Amendment 3 to AIS-156 (09/2022)

Specific Requirements for L Category Electric Power Train Vehicles

Amendment 2 to AIS-156 (08/2022)

Figure 1

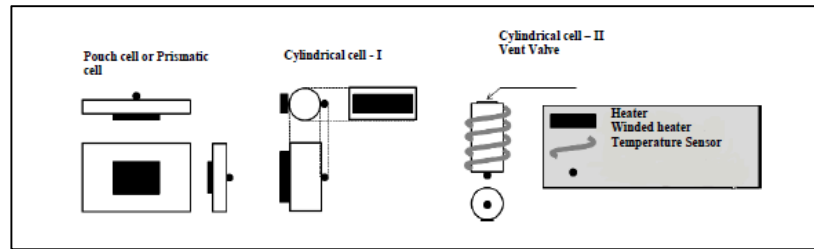
Note: As for the set-up using a heater, place a temperature sensor on the far side of heat conduction, for example, an opposite side of the position where heater is placed (see Figure 1). If it is difficult to apply the temperature sensor directly, place it at the location where the continuous temperature rise of initiation cell can be detected.

Figure 1

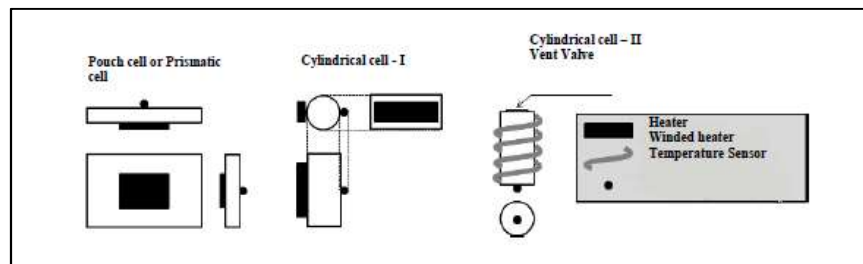
Note: As for the set-up using a heater, place a temperature sensor on the far side of heat conduction, for example, an opposite side of the position where heater is placed (see Figure 1). If it is difficult to apply the temperature sensor directly, place it at the location where the continuous temperature rise of initiation cell can be detected.
